# Technical Service Bulletin

## 42 Rear shock mounting noises

42 16 32 2042645/4 April 22, 2016. Supersedes Technical Service Bulletin Group 42 number 16-31 dated April 7, 2016 for reasons listed below.

Model(s)	Year	VIN Range	Vehicle-Specific Equipment
S3	2015 - 2016	All	With Audi magnetic ride

**Figure 1.** Rear shock absorber assembly showing rear shock mount (point 4).

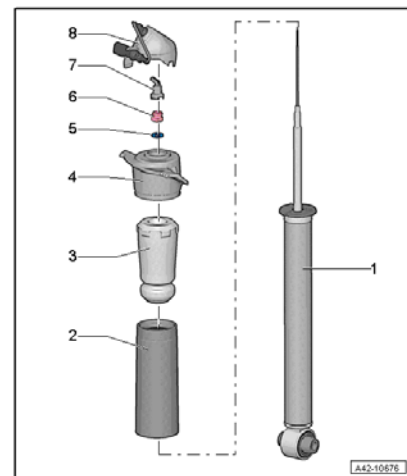
The rear shock mounts are causing the noises (Figure 1).

1. Verify that the noise is coming from the rear shock mounts.
2. Remove both rear shock assemblies and replace both rear shock mounts according to Elsa instructions.
3. Test drive to verify repair.
